SHOREHAM NUCLEAR POWER STATION

SNRC-858

Response to Request for Additional Information
Regarding Containment Liner Piping Penetrations
Shoreham Nuclear Power Station - Unit 1
Docket No. 50-322

PIPING PENETRATION DETAIL FOR

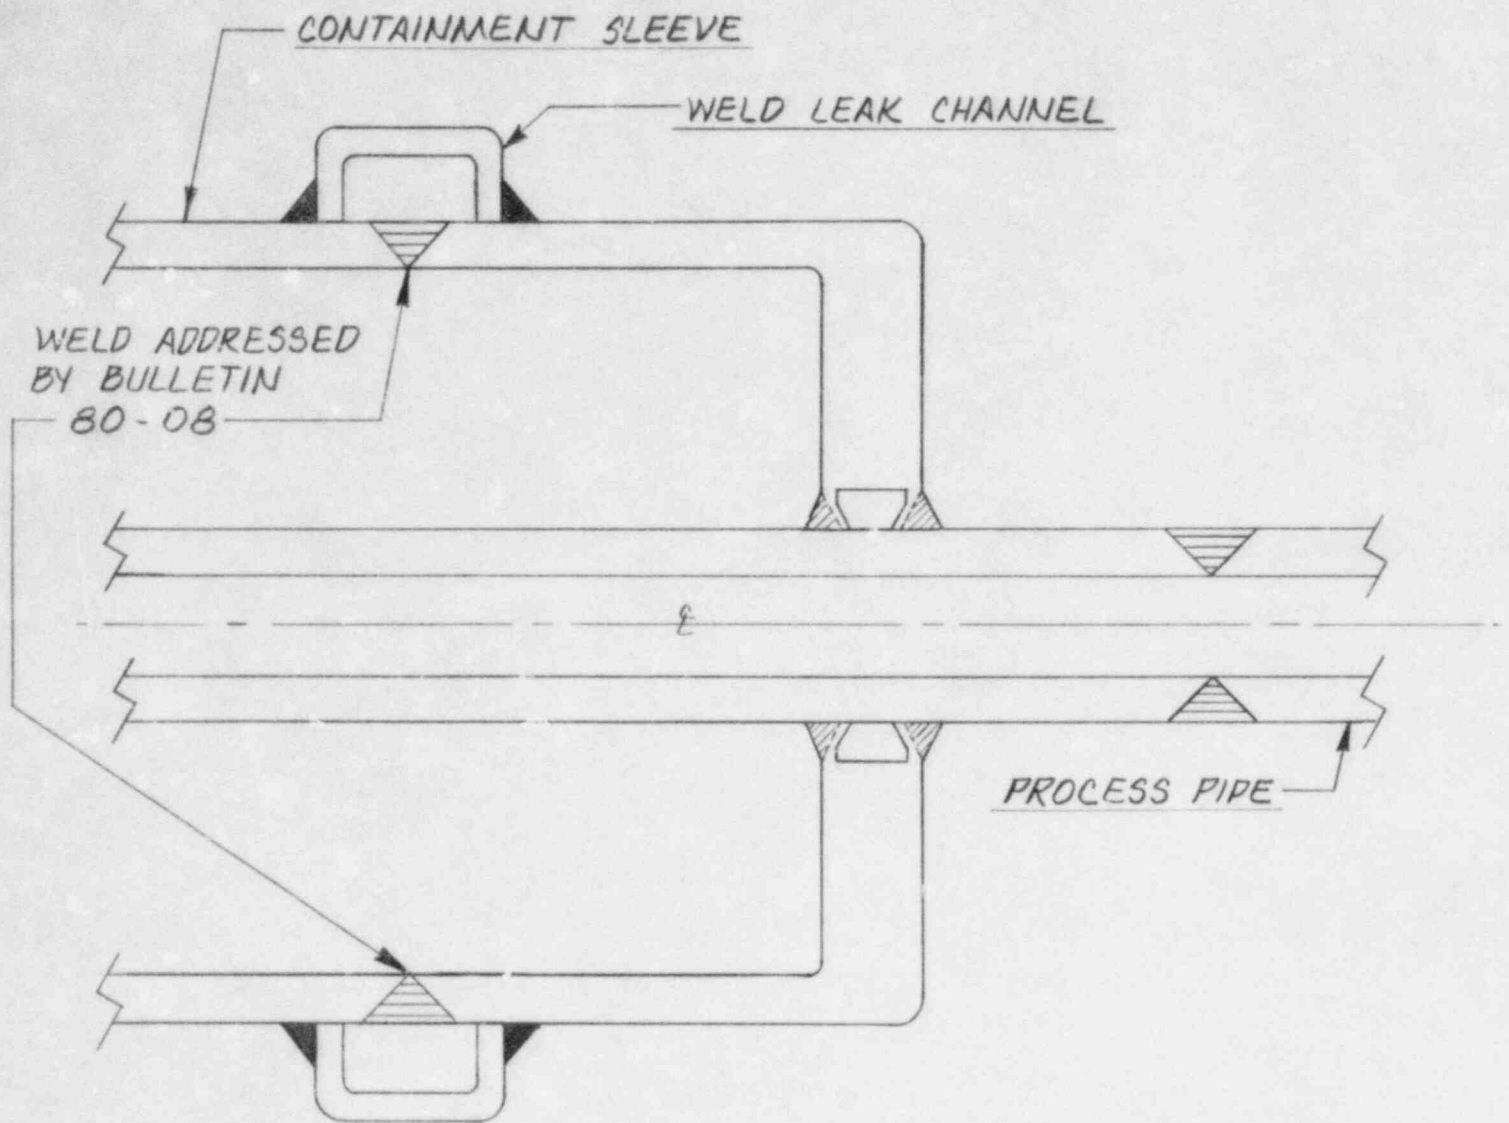
Question number 1 concerns the basis for MT examination of the welds between the primary containment penetration flued head and the outer sleeve (indicated in attachment 2 as "welds addressed by Bulletin 80-08"). Shoreham's SAR commitments forms the basis for MT examination of these welds. Additional details, including specific SNPS-1 FSAR references, can be found in reference 2, items "2a" and "3".

Regarding question four, with respect to planned In-Service Inspection (ISI) attachment 2 provides a sketch to help illustrate Shoreham's typical penetration configuration. In accordance with Section XI of the ASME B&PV Code (Subsections IWA and IWF) the area will be visually examined to determine the general mechanical and structural conditions of components and their supports.
